RE: Application number: A002171615 – Proposed rezoning of The Golf Course Riverfront Land from Rural and Parkland to Residential - Weekes Road - Moggill.

Permit Type: DA - IPA - Material Change of Use, DA - IPA - Reconfigure a Lot
Description of Proposal: Reconfiguration of a Lot (3 into 91 lots & park & road) and Preliminary Approval to override the Planning Scheme for residential uses

RE: Outstanding Issues

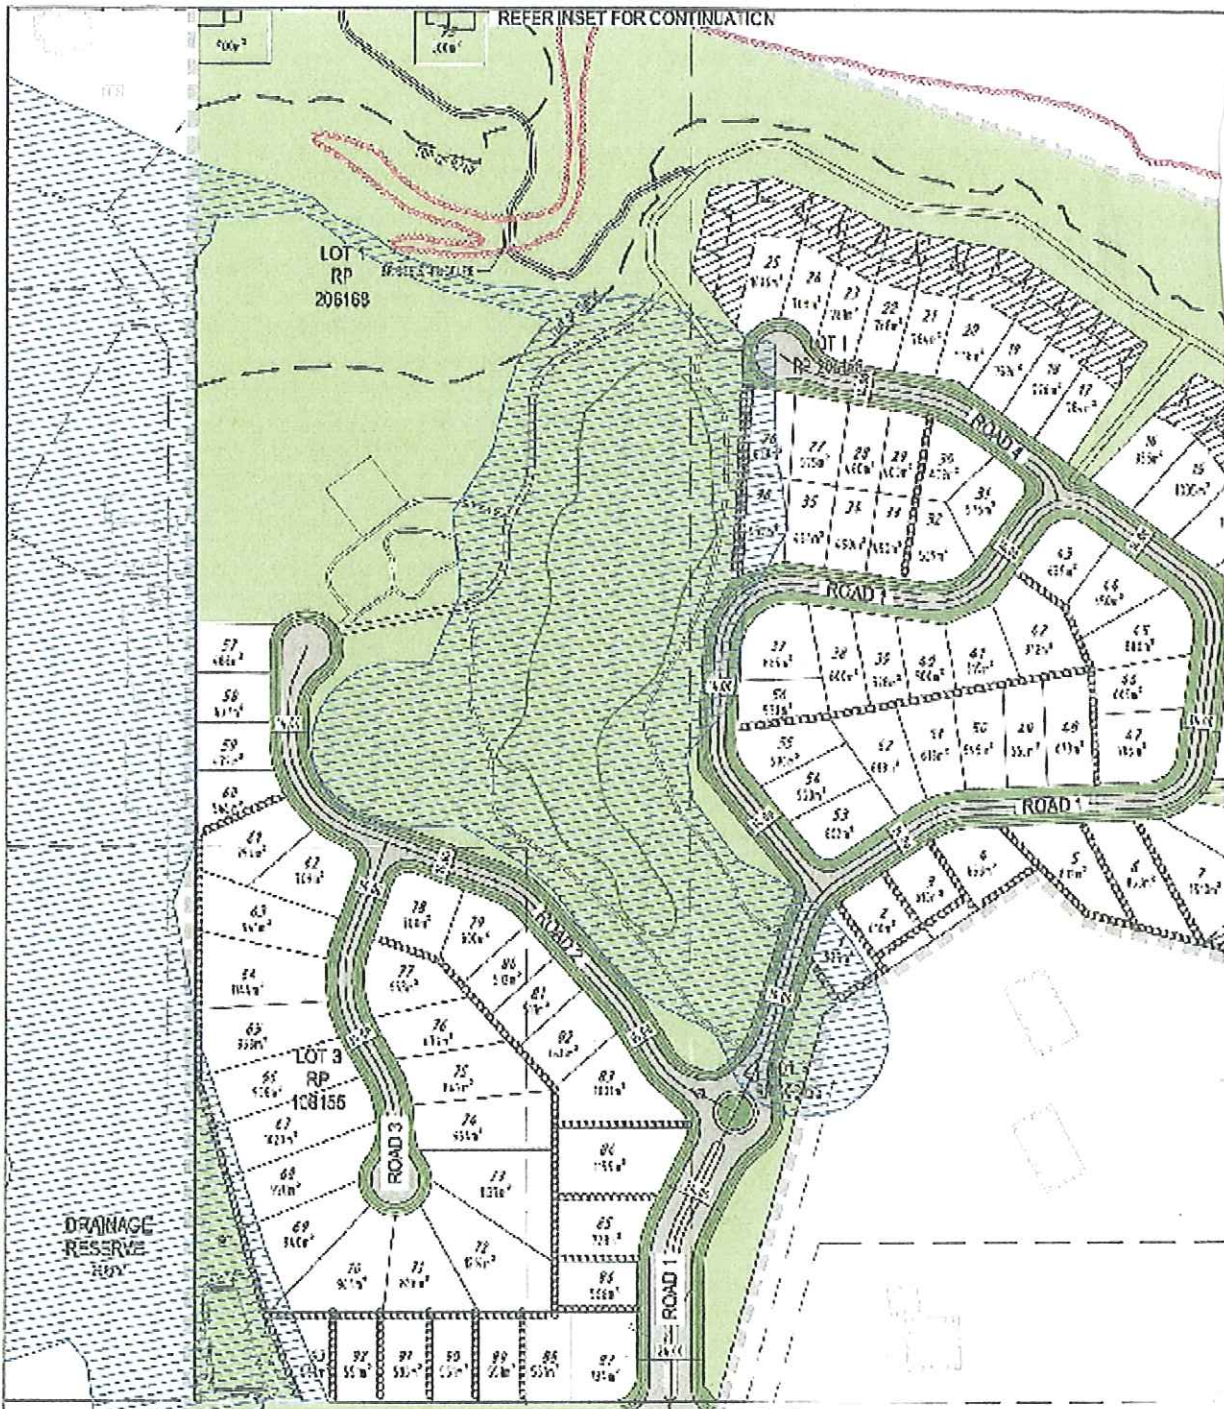
1. Accordingly, to substantially reduce the impact this development would have on our lifestyle, we request that lots 57 through 62 (Dwg DA-100 Rev A), and the Cul de-sac that services them, be removed from this development (again) and the land they would occupy be surrendered to Council as Parkland. In addition we request that any car park, or other facility, be removed from behind our property and be relocated in lieu of proposed lot 78 and that all pathways in this region of the development originate from there.

2. Accordingly, we request that lots 57 to 62 (Dwg DA-100 Rev A) be completely removed from this development and the land they would occupy be surrendered to Council as Parkland (these are the same lots that would have the greatest impact on our lifestyle). Any proposed compromise that could eventuate in any obstacles (including fences) being encountered during a hurried night evacuation from our house to substantially higher ground is unacceptable.

The removal of lots 6 through 25 (Dwg DA-100 Rev A) from this development and insisting on the mandatory 100 metre Precinct 1 river corridor being maintained, whilst leaving roads 4 and 5 unchanged and requiring an elevated (rather than low level) pedestrian creek crossing to Booker Place park would go a long way towards delivering such a priceless asset to the community as compensation for the “windfall” the community would be granting the developer should any development of this site proceed.

5. Accordingly, we request lots 6 through 25 (Dwg DA-100 Rev A) be removed from this proposal and the land they would occupy be surrendered to Council as Parkland and/or conservation area. We also request that all proposed residential development within the 100 metre Precinct 1 river corridor be removed whilst leaving roads 4 and 5 substantively unchanged and Council insist on an elevated pedestrian crossing of the creek, to Booker Place Park.
